**RE: Preliminary Review Summary Letter – Pre-Application 18 122343 XX for a Proposed Subdivision at 3520 Baycrest Avenue**

Subject: **Works and Services Requirements for 3520 Baycrest Avenue, (18-122343 – XX | 18-123254 – DEVS)**

To: Jenna Dallmeyer, Planning Technician  
From: Matthew Huk, Forest Management Technician  
Subject: **Urban Forestry Comments on 3520 Baycrest Pre-application**

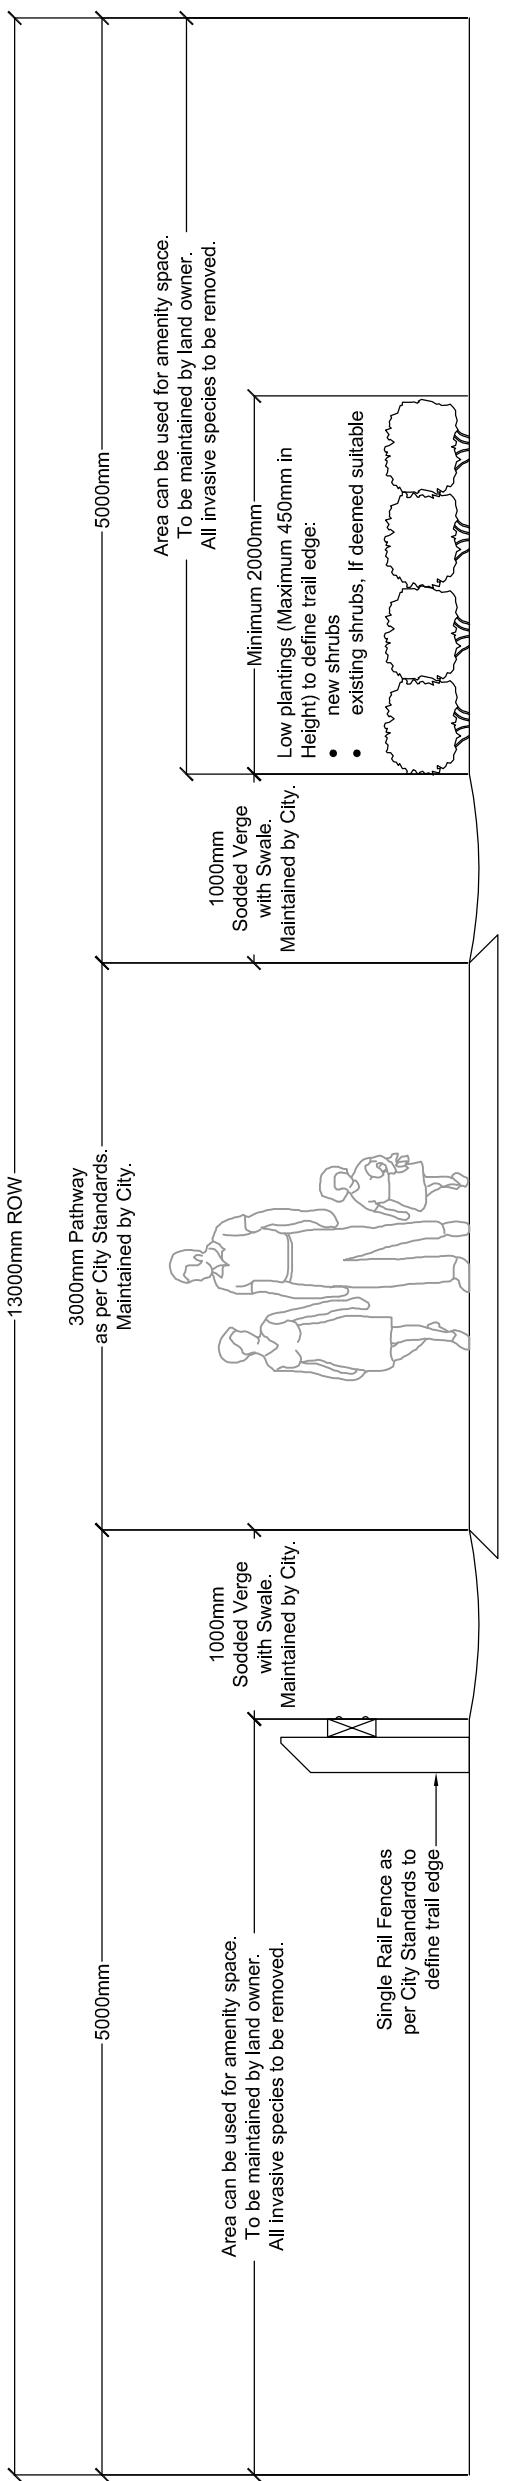
See attached Trail right-of-way details specification, which includes the trail and owner-maintained landscape buffer on each side of the trail. Direct access gates from the proposed lots to the trail would be supported.

1. 3 m wide trail granular trail;
2. 1 m sodded verge swale on either side of trail;
3. 5 m public statutory right-of-way that the City will maintain;
4. Beyond the 5 m statutory right-of-way will be owned and maintained by future residents;
5. Maximum 1.2 m high fence adjacent to trail. Alternate is a planted buffer;
6. Granular trail material is 9 mm minus;
7. Max slope 8%;
8. Show existing contours and proposed contours;
9. Show trail slopes; and
10. To be designed by the project landscape architect for review by Park Planning and Design.
